Subject: Contract No. 200-2004-03805, Task Order 3: The Review of NIOSH/ORAU Procedures and Methods Used for Dose Reconstruction

**NATIONAL INSTITUTE OF  
OCCUPATIONAL SAFETY AND HEALTH**  
**ADVISORY BOARD ON RADIATION AND WORKER HEALTH**

***REVIEW OF NIOSH/ORAUT PROCEDURES AND METHODS  
USED FOR DOSE RECONSTRUCTION***  
**Supplement 1**

Figure 3.7-1. K-S and A-D Statistics for All Distributions Fitted to a Sample of 10,000 Products using Crystal Ball 2000 Batch-Fit Procedure

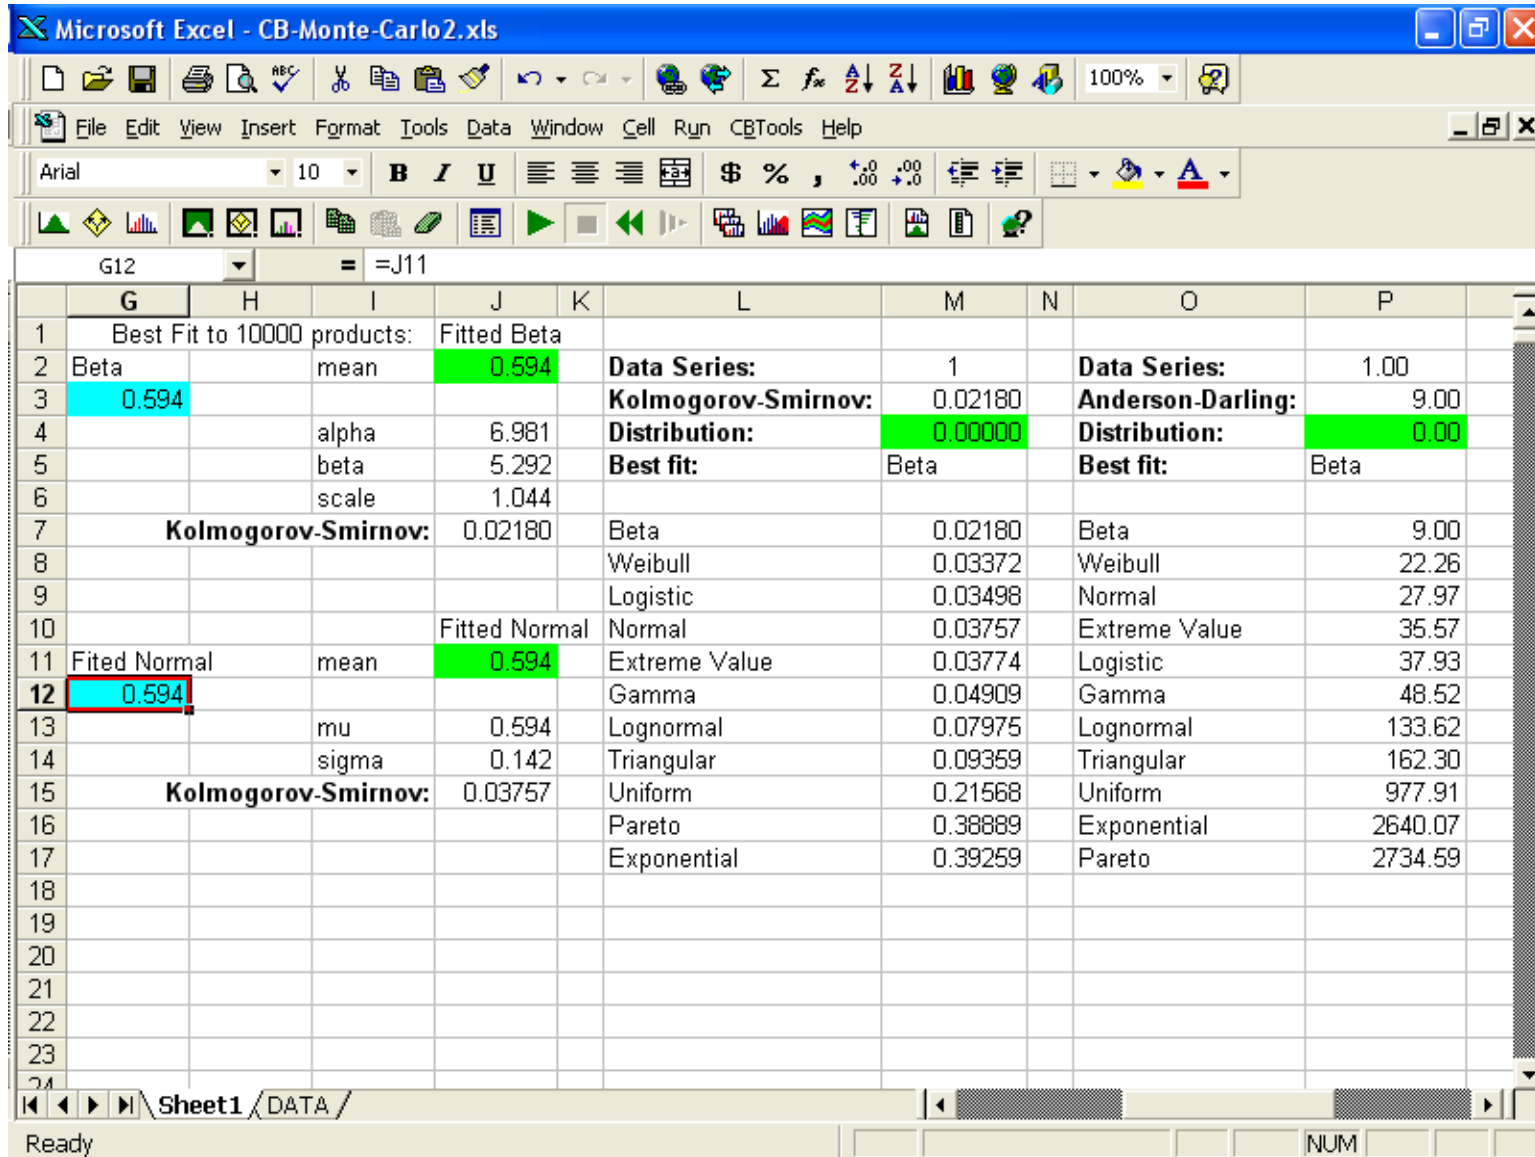
The results, shown in Figure 3.7-1, indicate that the beta distribution was found to be the best-fitting distribution under both criteria. In both cases, the second-best fit was obtained using a Weibull distribution. The normal distribution ranks third when using the A-D criterion, and fourth when using the K-S criterion.

**Figure 3.7-4. Comparison of Statistics Obtained from Samples of Size 10,000 from the Best-Fitting Beta Distribution and the Best-Fitting Normal Distribution**

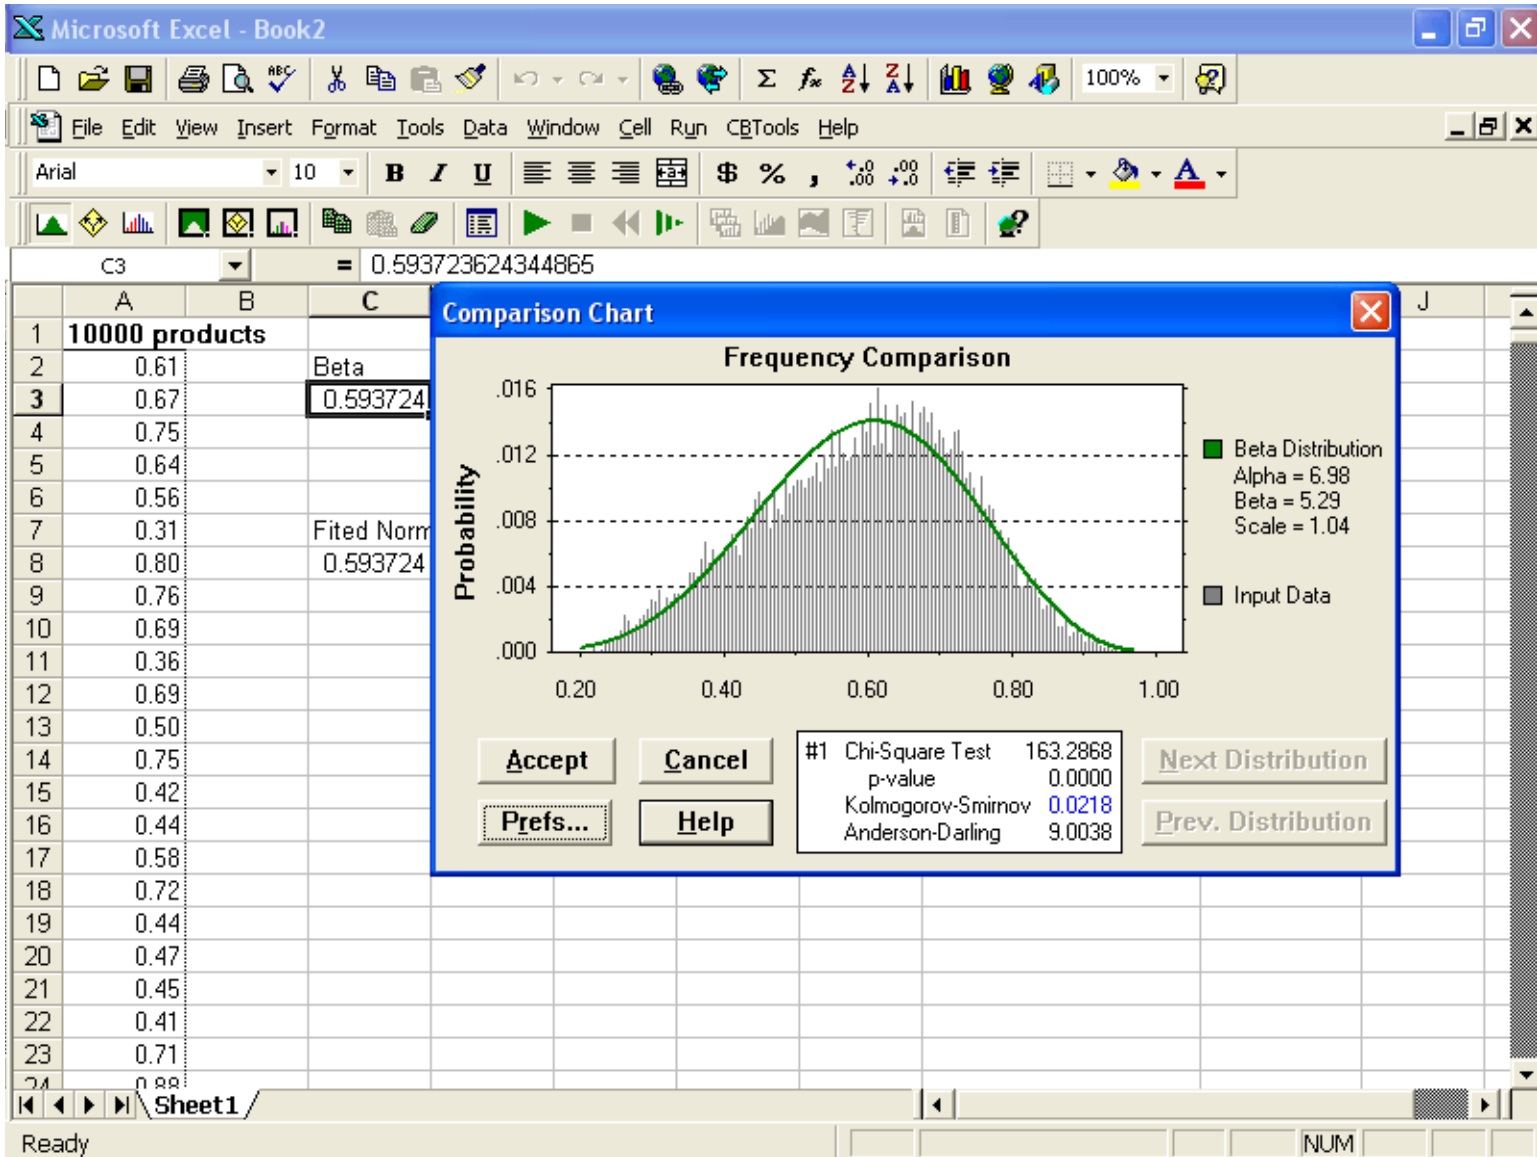
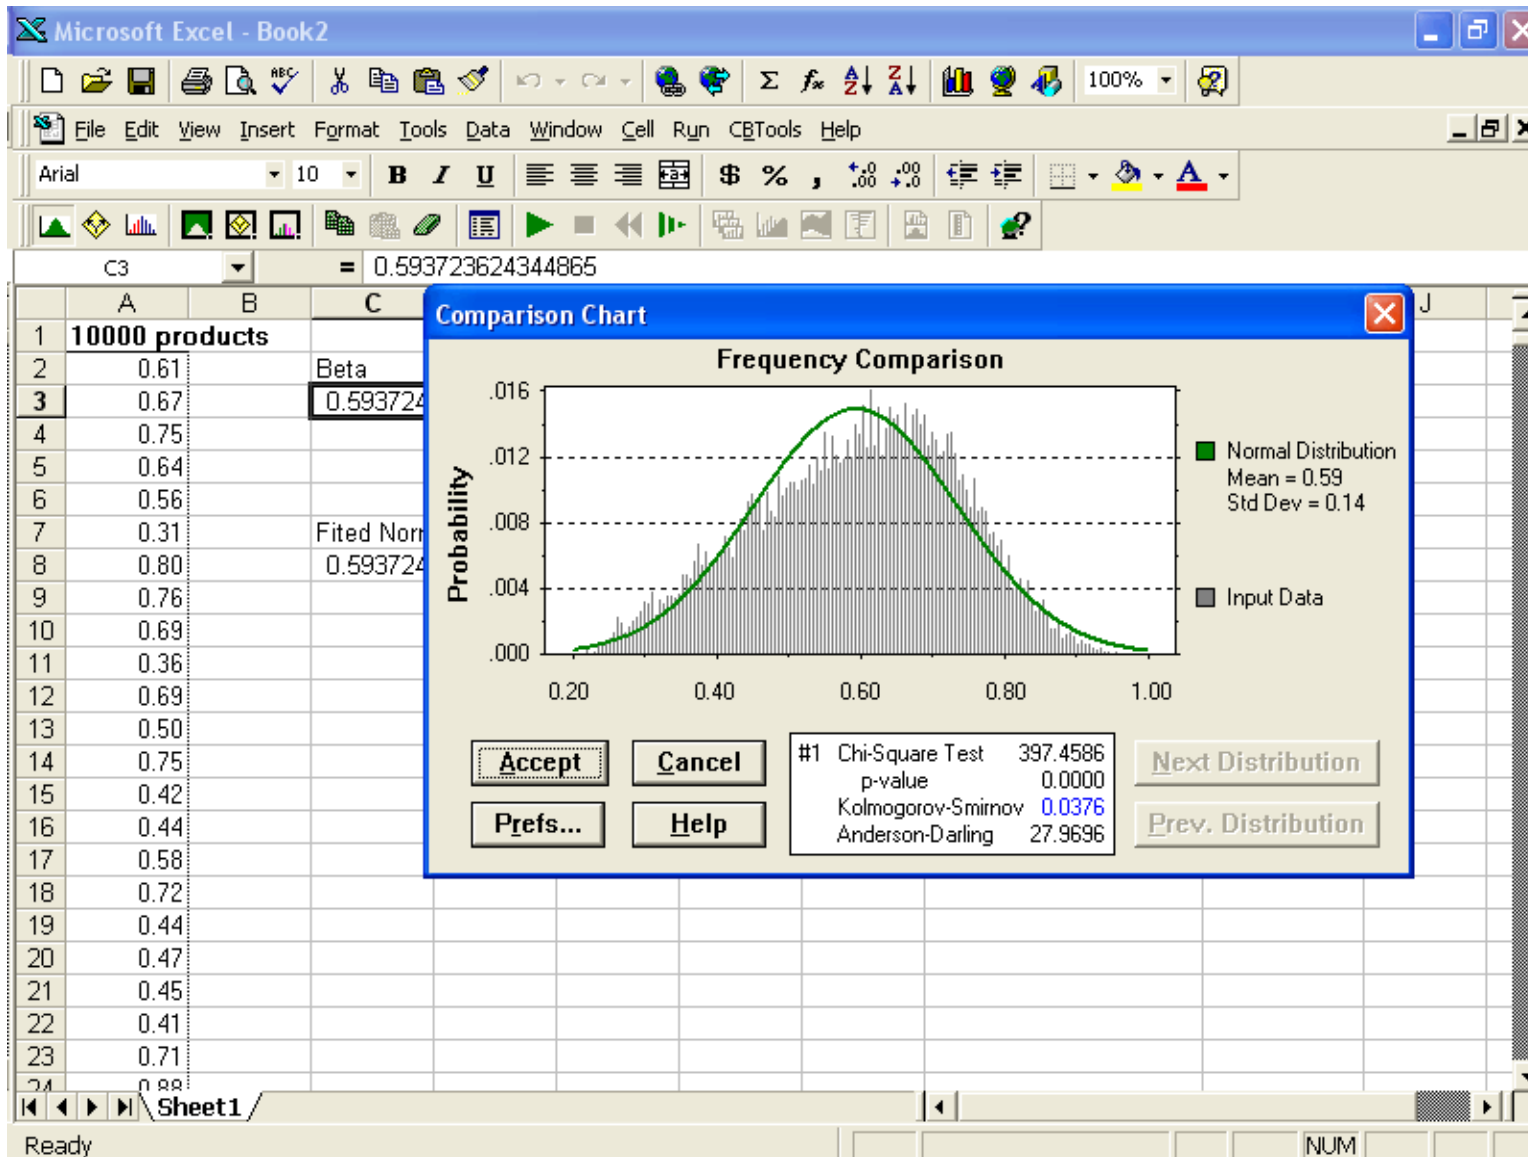
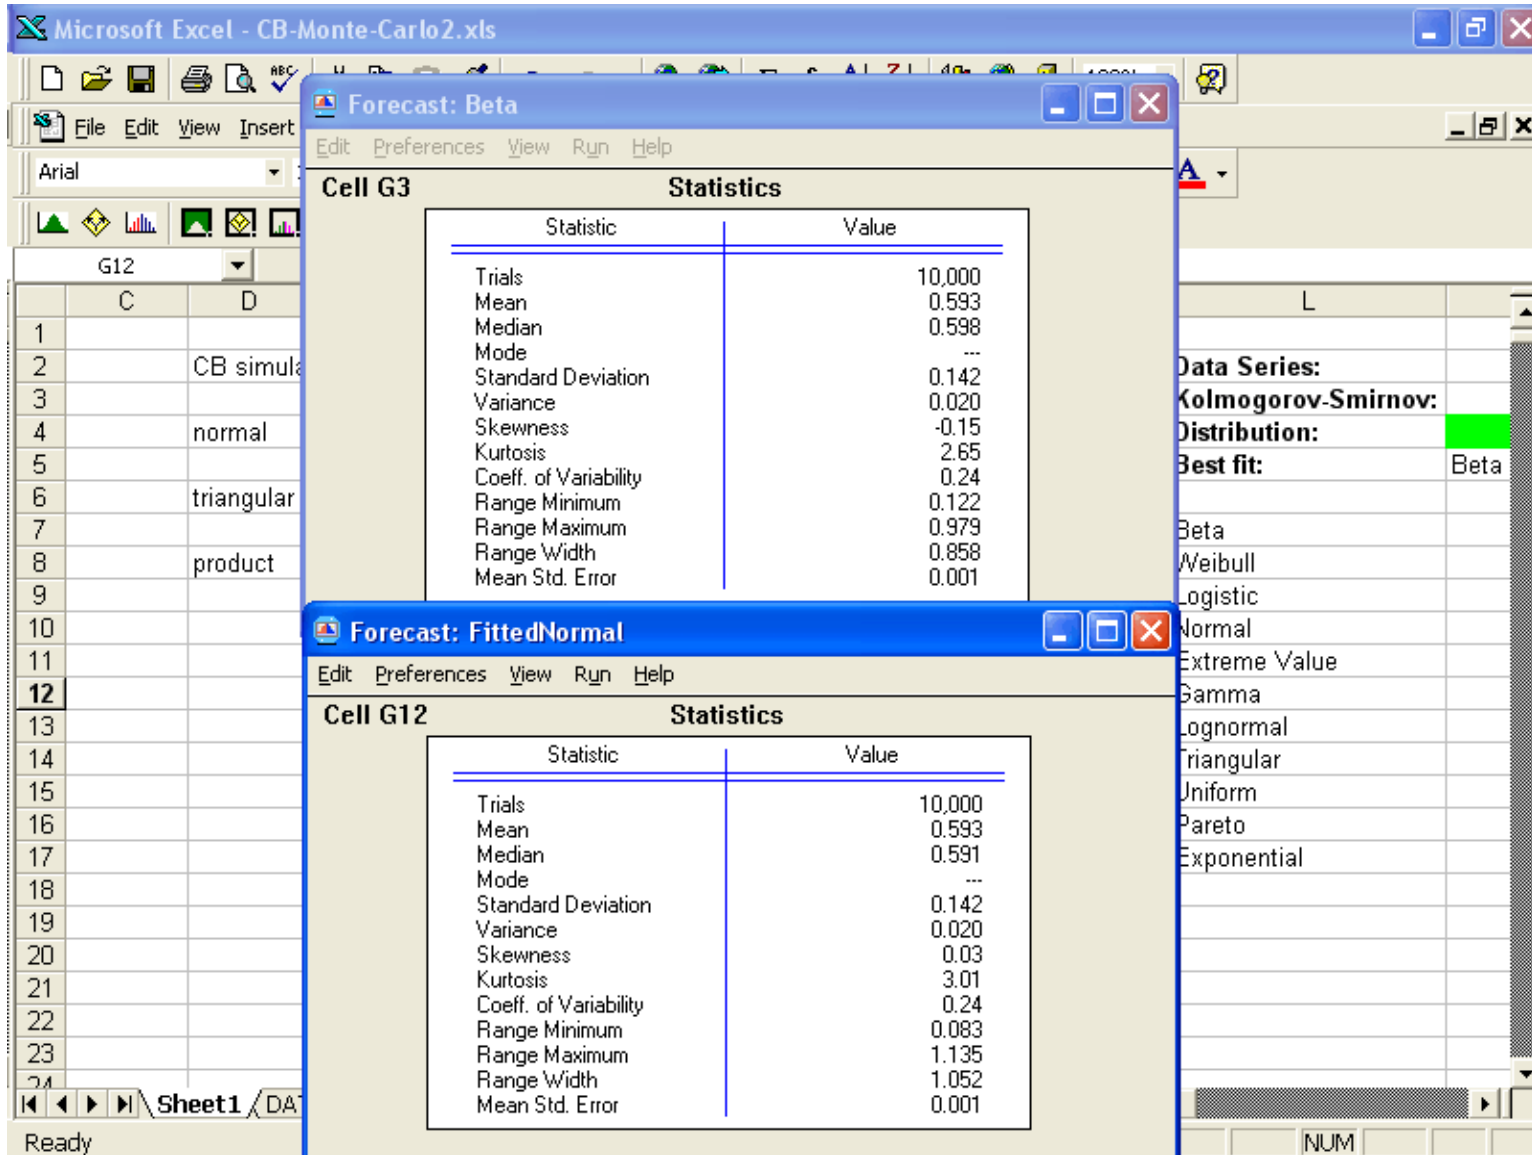
Two samples of size 10,000 were simulated in Crystal Ball 2000 using the fitted beta and normal distribution with parameters stated above. Despite the clearly better fit of the beta distribution based on the statistical tests, there is little difference in the statistics obtained from the two simulated data sets, as shown in Figure 3.7-4. This confirms that the best-fitting normal distribution provides a good approximation for the distribution of the product organ doses in the example selected. If the normal distributions for the dosimeter reading have a larger standard deviation than the 0.10 value in this example, it is likely that a normal distribution will continue to provide a good approximation to the distribution of the product's organ doses.
